## DEVELOPMENT APPLICATION

<b>APPLICATION NUMBER:</b>	PLN-25-186
<b>PROPOSED DEVELOPMENT:</b>	Change of Use to Medicare Mental Health Centre (Business and Professional Services), Partial demolition, Alterations and Additions.
<b>LOCATION:</b>	388-388a Main Road Glenorchy
<b>APPLICANT:</b>	MC Planners
<b>ADVERTISING START DATE:</b>	19/09/2025
<b>ADVERTISING EXPIRY DATE:</b>	3/10/2025

**FURTHER INFORMATION REQUEST DEVELOPMENT APPLICATION - CHANGE OF USE TO MEDICARE MENTAL HEALTH CENTREA (BUSINESS AND PROFESSIONAL SERVICES), PARTIAL DEMOLITION, ALTERATIONS AND ADDITIONS - 388-388A MAIN ROAD GLENORCHY**

### **388-388A MAIN ROAD GLENORCHY – RESPONSE TO COUNCIL RFI**

- Drawing 25482-01

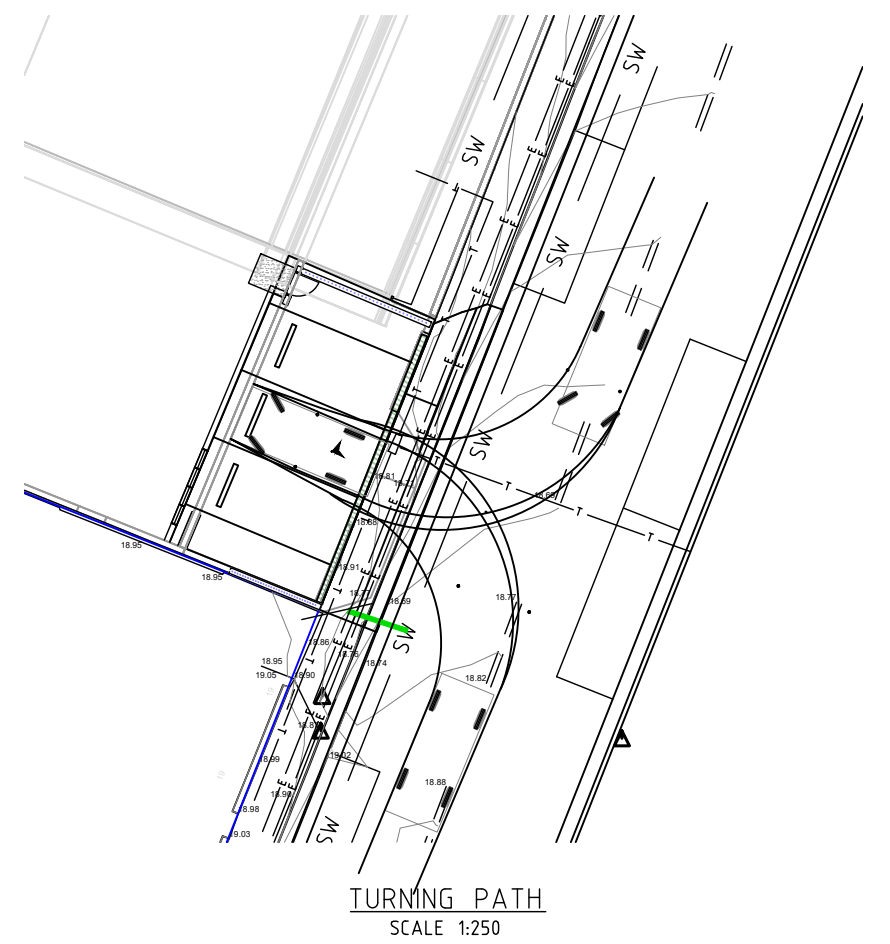
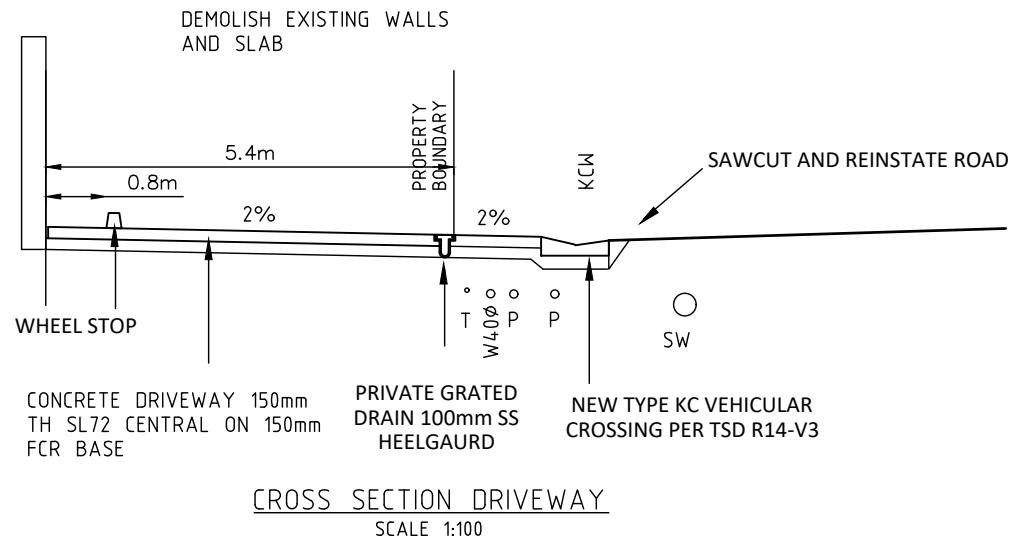
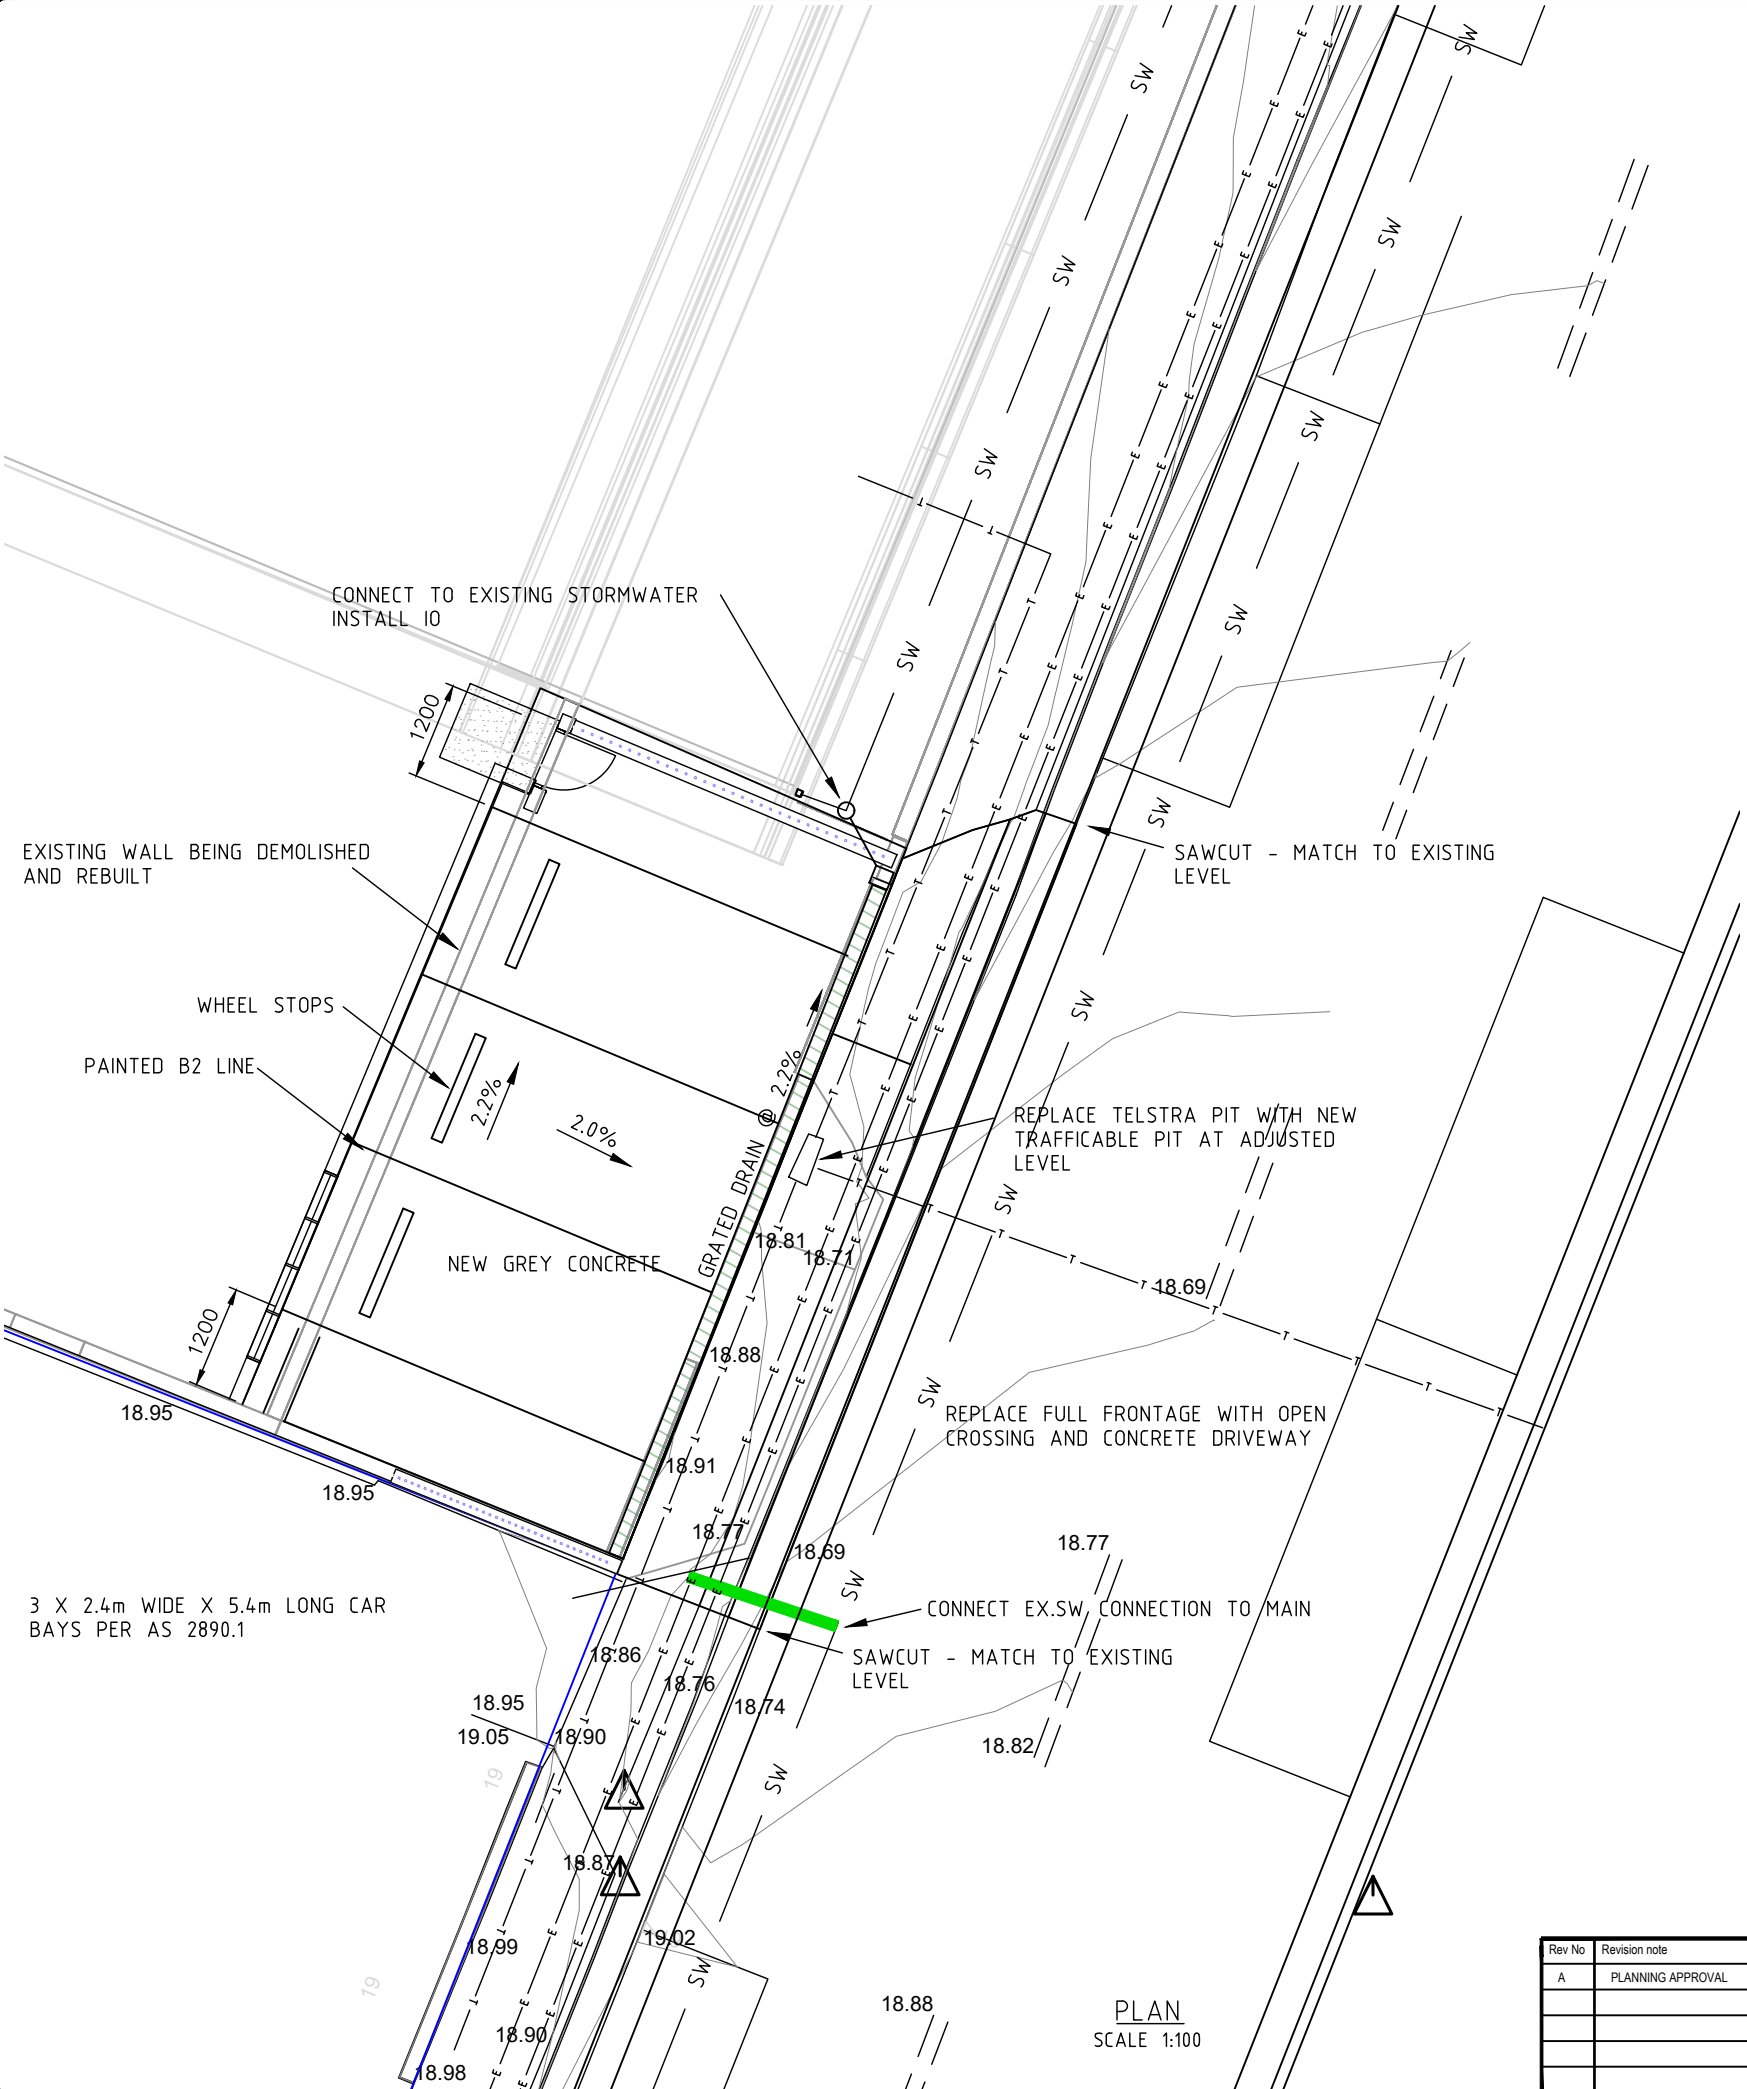
*C2.6.1 Construction of parking areas Please provide a stormwater concept plan showing the capture and disposal of all stormwater run-off from the proposed driveway, parking and any new hardstand areas to Council's approved outlet.*

*A concept stormwater plan in accordance with the Stormwater policy is required.*

*o All runoff must be drained via gravity to the proposed outlet. 1% minimum fall toward the outlet must be achieved. This needs to be clearly demonstrated in the plan.*

*o Please provide a detailed plan showing how crossover extension can be achieved considering existing pit and adjacent property SW connection. Pit level is being adjusted and trafficable lid fitted. Existing stormwater kerb connection is being connected to stormwater main.*

*o Add the manoeuvring template demonstrate sufficient turning room from the road to the proposed parking spaces, providing on-street spaces are all occupied on both sides of the road. Swept paths shall be with 300mm clearance and be in a continuous motion. Added*

*o Driveway grades and transition must be in accordance with the standard. Complied with.*

**Please refer to the attached drawing 25482-01. The carpark drains to a grated drain located on the boundary. The grated drain is connected to the adjacent stormwater.**

Please refer to the attached drawing 25482-01.

**Figure 1    Parking Dimensions**

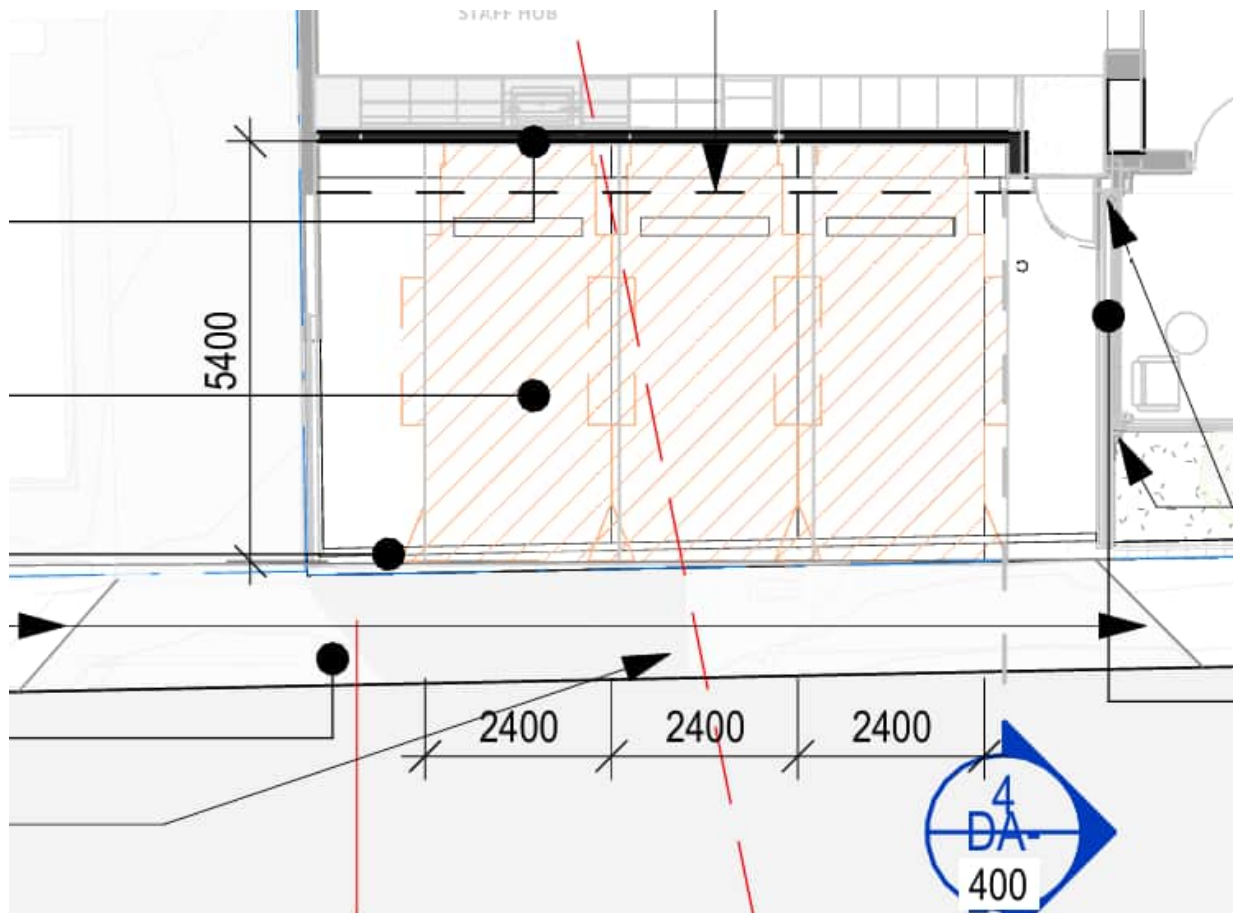
*"Clarification of the intended number and location for the car parking proposed on site. The TIA and Plans indicate three (3) car parking spaces, however the planner's report indicates four (4) spaces. Please confirm the correct number of spaces and update documents to ensure consistency through the application".*

*"The maximum parking grade is 5% or 1 in 20, please confirm and annotate this on the plan".*

A total of three (3) spaces are proposed. These are detailed in Figure 1.

- Width                2.4 metres – AS2890.1 requirement = 2.4 metres (satisfied)
- Length             5.4 metres – AS2890.1 requirement = 5.4 metres (satisfied)
- Aisle width        7.6 metres – AS2890.1 requirement = 5.8 metres (satisfied/ exceeded)

It is noted that the dimensions queried in Council’s RFI (notably the space length measured to be 4.9m) were not the full space length, but the distance from the back of space to the overhead roof structure. The fully dimensioned spaces are shown in Figure 1.

**Figure 2 B85 Vehicle Swept Paths**

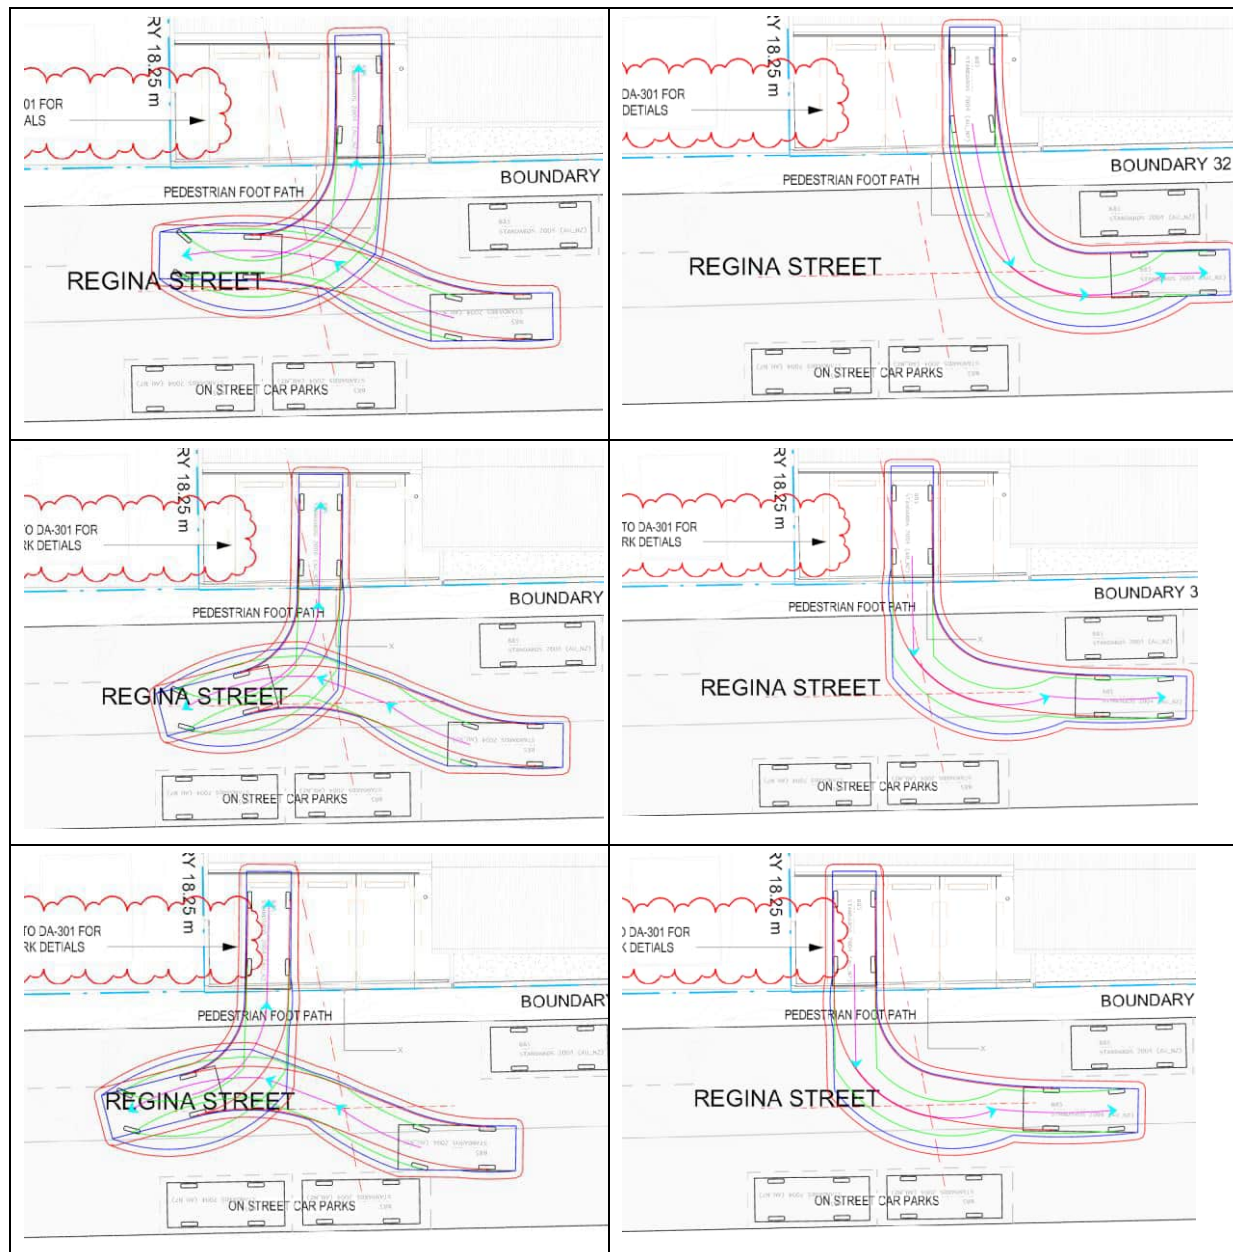
*"Add the manoeuvring template demonstrate sufficient turning room from the road to the proposed parking spaces, providing on-street spaces are all occupied on both sides of the road. Swept paths shall be with 300mm clearance and be in a continuous motion".*

As noted previously, all parking spaces comply with AS2890.1 requirements, with significantly more aisle width available for manoeuvring (7.6 metres from the back of the proposed parking spaces to the edge of the on-street parking space opposite the proposed parking). On this basis swept paths would not normally be required, as the spaces are 'deemed to comply' and would obviously facilitate the swept path of a B85 vehicle.

Regardless, swept paths are provided in accordance with AS2890.1 requirements as shown in Figure 2. The swept paths demonstrate accessibility for a B85 vehicle entering and departing from/ to Main Road. Similar results are achieved from the Barry Street end of Regina Street.

**Figure 3 AS2890.1 Pedestrian Sight Line Requirements**

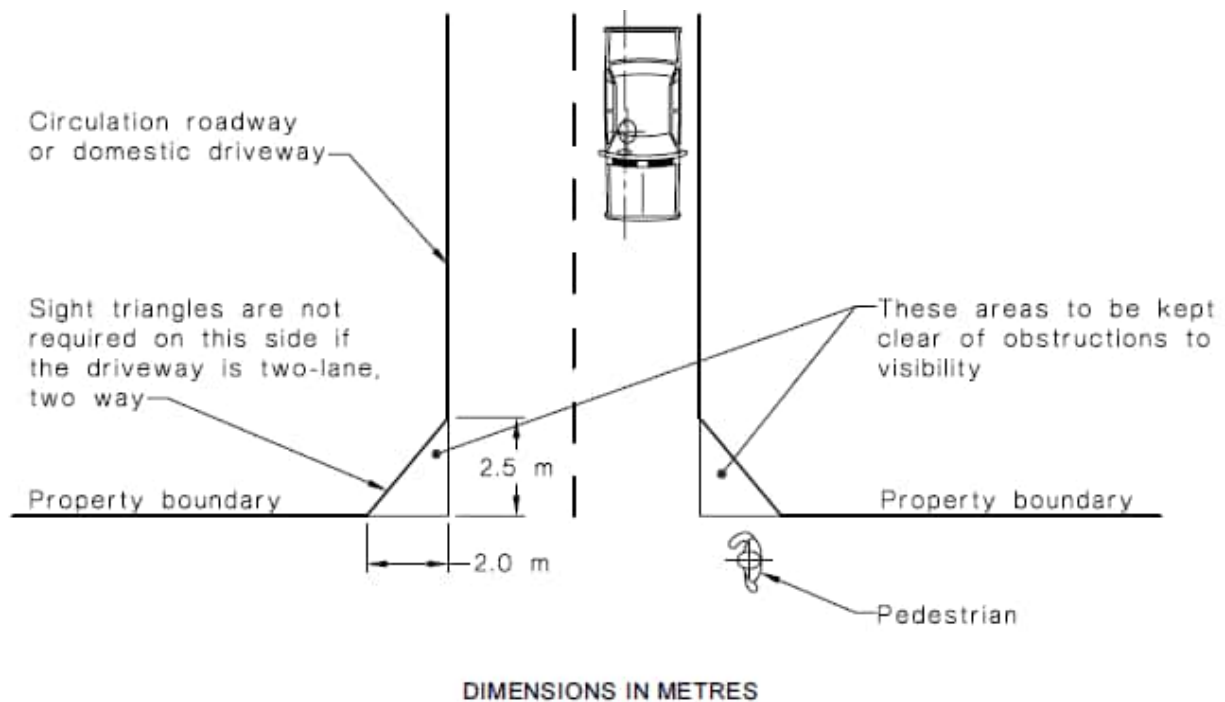
- In the TIA, demonstrate that pedestrian sight lines are met in accordance with AS2890.1, in which sight lines need to be independent from the adjoining property. Otherwise amend plans to comply.

In relation to pedestrian sight lines, Section 3.2.4(b) of AS2890.1 states: "*clear sight lines as shown in Figure 3.3 shall be provided at the property line to ensure adequate visibility between vehicles leaving the car park or domestic driveway and pedestrians on the frontage road footpath*". The requirements of Figure 3.3 are reproduced in Figure 3.

In this case the parking consists of three 90-degree parking spaces with no driveway provision. The parking spaces are located immediately behind the pedestrian footpath. The requirements of Figure 3.3 are therefore not relevant due to the lack of driveway provision (ie. vehicles are parked immediately within the garage and do not utilise a driveway or circulation aisle).

The provision of a driveway would result in vehicles utilising the access at higher speed than would occur through parking manoeuvring of vehicles using the parking spaces.
